SUSQUEHANNA - UNIT 1  
92-06120159

FLOW DEPENDENT MCPR OPERATING LIMIT  
FIGURE 3.2.3-1

NFE-1-07-010 REV. 2

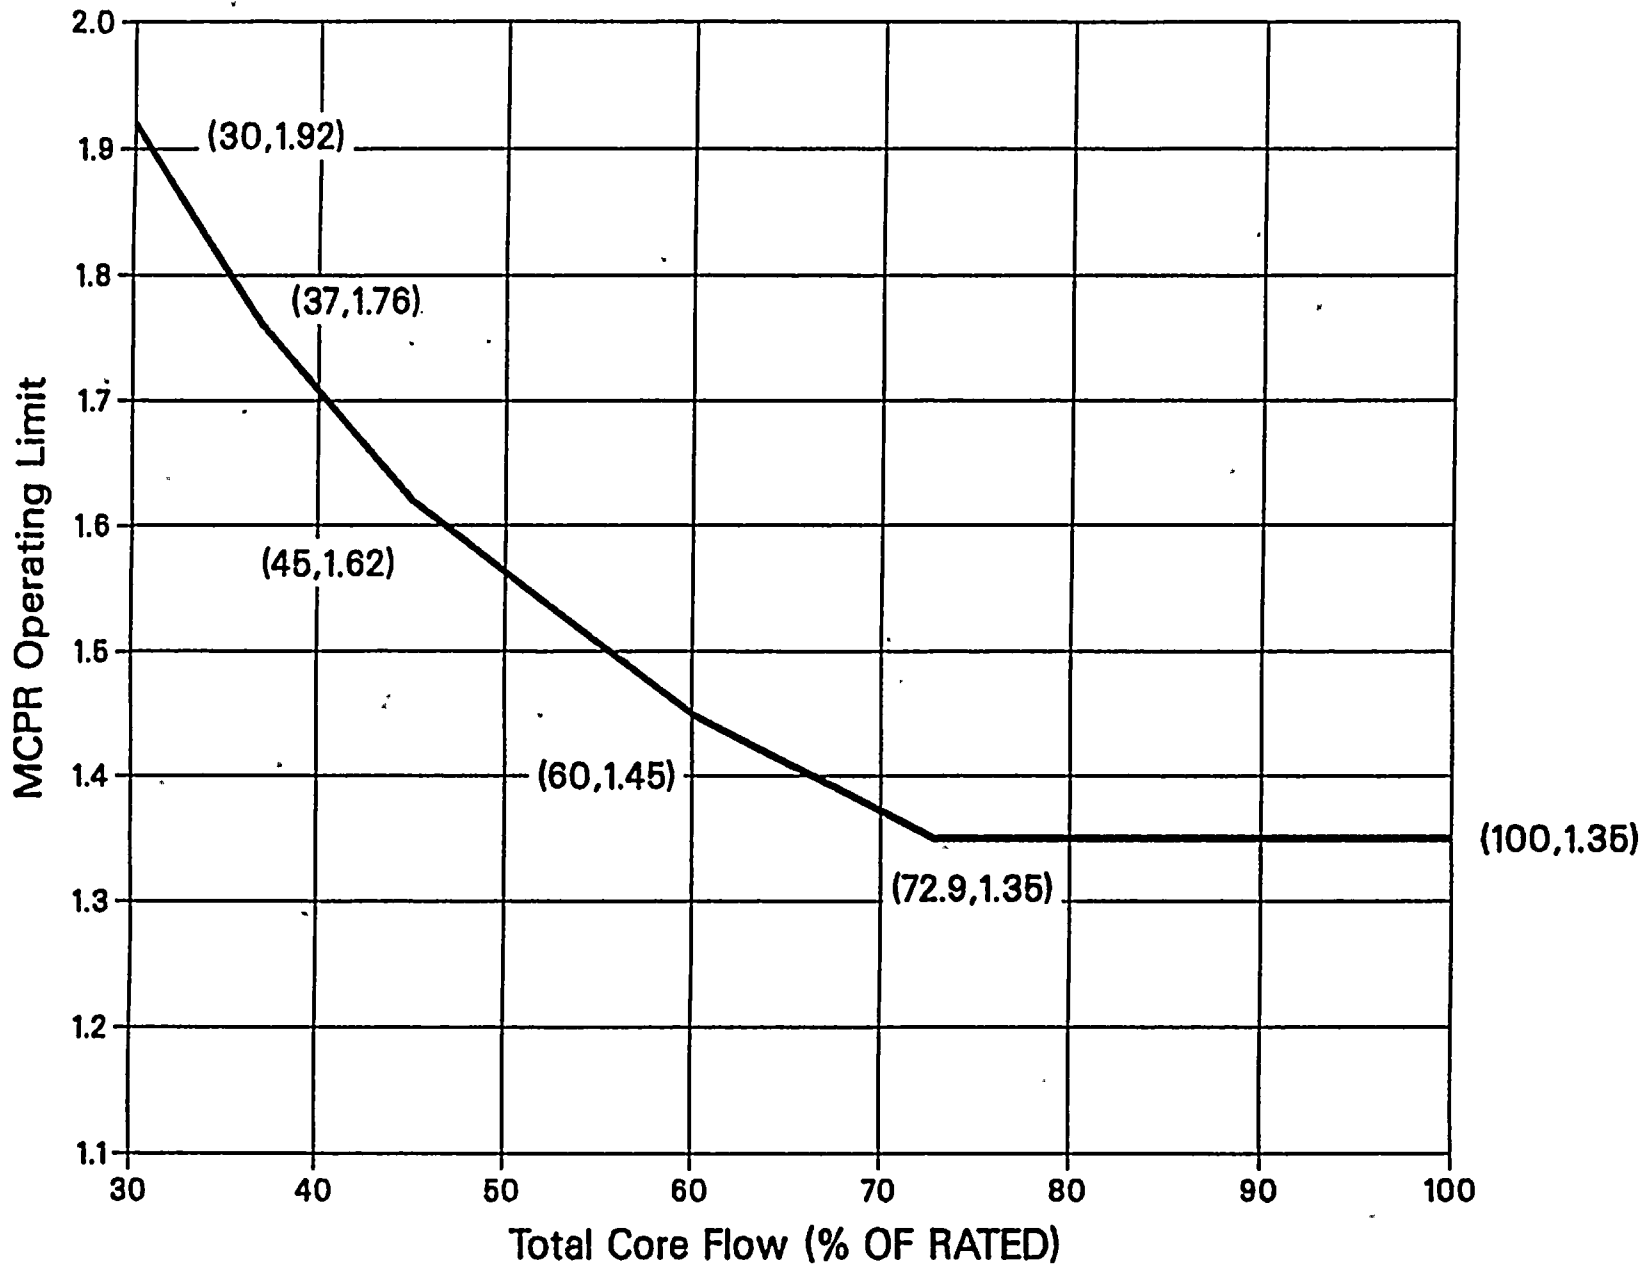
REPLACE WITH CORRECTED FIGURE ON NEXT PAGE

ORIGINAL  
CALCULATION

To account for the RETRAN code uncertainty, the RCPR is multiplied by 1.04 (Reference 2) as follows;

$$RCPR_f = 1.04 * RCPR$$

To determine the corrected delta-CPR (delta-CPR<sub>f</sub>) for the event, the equation for  $RCPR_f$  can be rearranged as follows;

$$RCPR_f = \frac{\text{delta-CPR}_f}{1 + \text{delta-CPR}_f}$$

$$RCPR_f * (1 + \text{delta-CPR}_f) = \text{delta-CPR}_f$$

$$\text{delta-CPR}_f = \frac{RCPR_f}{1 - RCPR_f}$$

$$MCPROL = 1.06^* + \text{delta-CPR}_f.$$

CORRECTED FIGURE

# REVISED CALCULATION

To determine the MCPR vs Core Flow operating limits that the new analyses produce, the RCPR values must first be corrected for the RETRAN code uncertainty and then a MCPR operating limit can be 'back-calculated'. This MCPR operating limit will be based on a MCPR safety limit of 1.06 for this calculation. The original U1C7 RFCF analysis did not correctly calculate the MCPR operating limits. Revision 1 of this package shows that the safety limit must be used when back calculating a delta-CPR or MCPR operating limit from the value of RCPR with the code uncertainty applied to it. The procedure that follows correctly accounts for the safety limit when calculating the MCPR operating limit and is used to calculate operating limits for the new U1C7 RFCF analysis.

To account for the RETRAN code uncertainty, the RCPR defined in Section D.3.2 is multiplied by 1.04 (Reference 2) as follows;

$$RCPR_f = \frac{MCPROL - SL}{MCPROL} \quad ; (SL = \text{Safety Limit})$$

$$MCPROL = \frac{SL}{1 - RCPR_f}$$

$$MCPROL = \frac{1.06}{1 - RCPR_f}$$

FLOW DEPENDENT M CPR OPERATING LIMIT

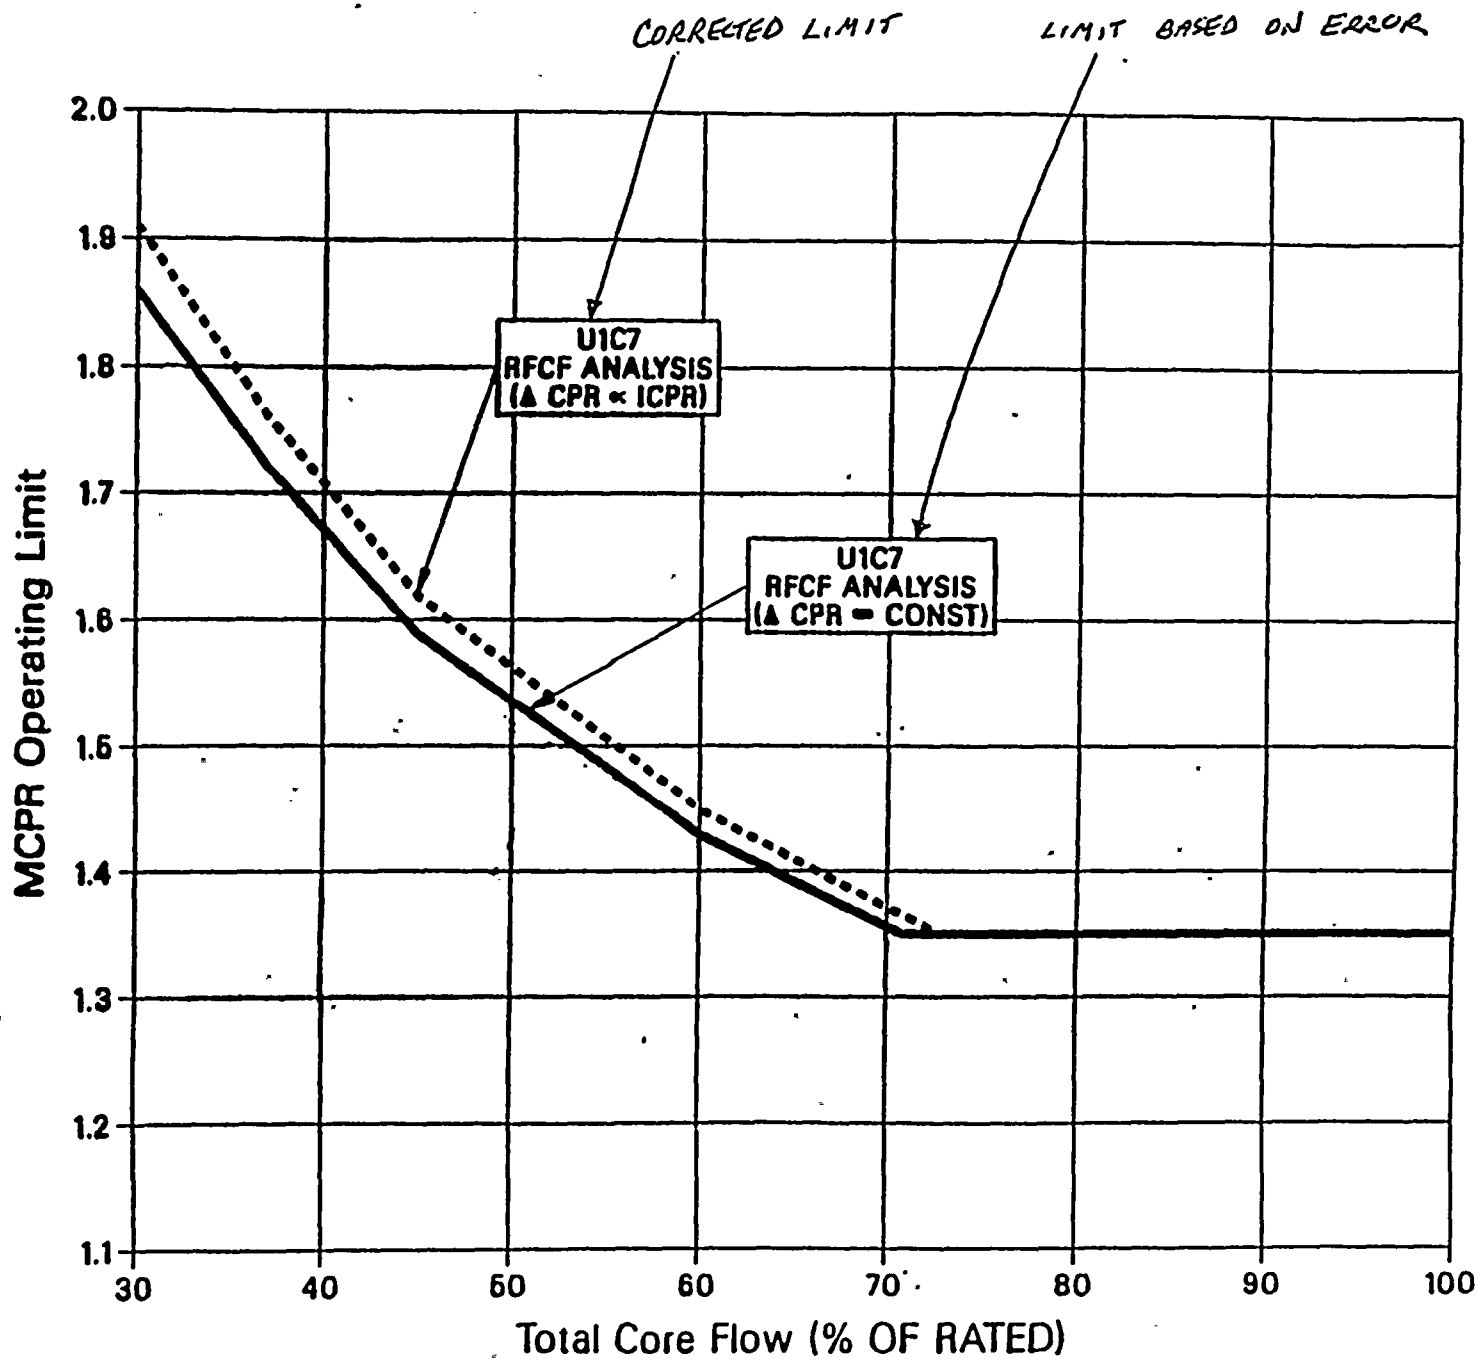
*DATA BASED ON CALCULATIONAL ERROR*

Core Flow (% Rated)	delta- CPR	MCPROL
30.0	0.80	1.86
37.0	0.66	1.72
45.0	0.53	1.59
60.0	0.37	1.43
70.9	0.29	1.35*
100.0	0.29	1.35*

*CORRECTED DATA*

Core Flow (% Rated)	delta- CPR	MCPRO
30.0	0.86	1.92
37.0	0.70	1.76
45.0	0.56	1.62
60.0	0.39	1.45
72.9	0.29	1.35*
100.0	0.29	1.35*
